RFI #: 75
 Date: 3/13/2012
 Job: EB-02 Keller Springs Lofts
 Phone: 877-777-5115

Subject: Forming grade beams per SK#1

RFI #: 82
 Date: 3/21/2012
 Job: EB-02 Keller Springs Lofts
 Phone: 877-777-5115

Subject: Dowels at Pier Caps

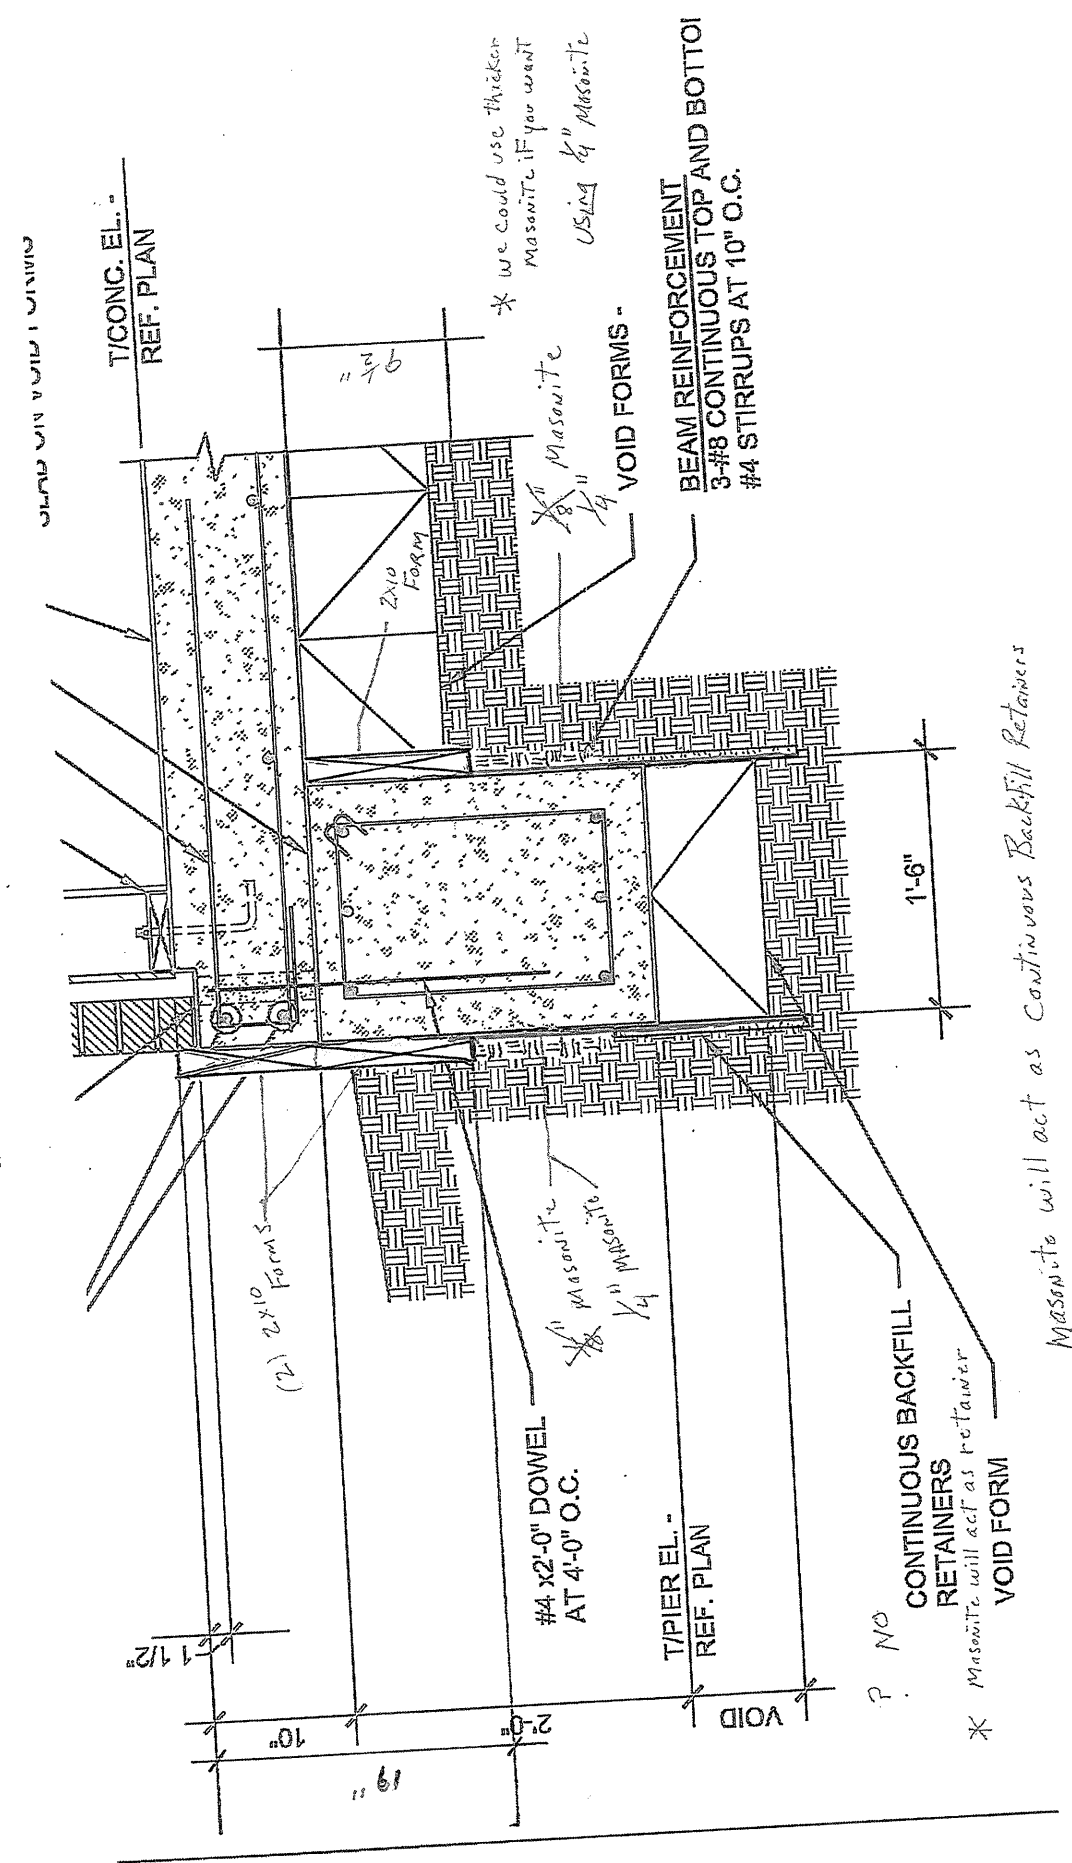
Does the same principal hold for the building piers. I know we dug a test hole in the courtyard of the East bldg, and hit rock at about 8 1/2' from F.F. We did the same thing on the West Bldg, and hit rock around 12'. Just wanted to confirm that 5' into Grey Limestone was sufficient.

Yes, it is acceptable to terminate the building piers once they have achieved the 5 feet of penetration into the bearing strata as determined by the geotechnical engineer per the structural drawings. If you have questions or require additional information regarding this matter, please do not hesitate to contact us.

Per our discussion, the 17'-0" minimum depth requirement indicated in 1/SG3.01 does not need to be met provided that the piers penetrate a minimum of 5'-0" into the bearing strata as indicated on the structural drawings. If you have questions or require additional information regarding this matter, please do not hesitate to contact us.
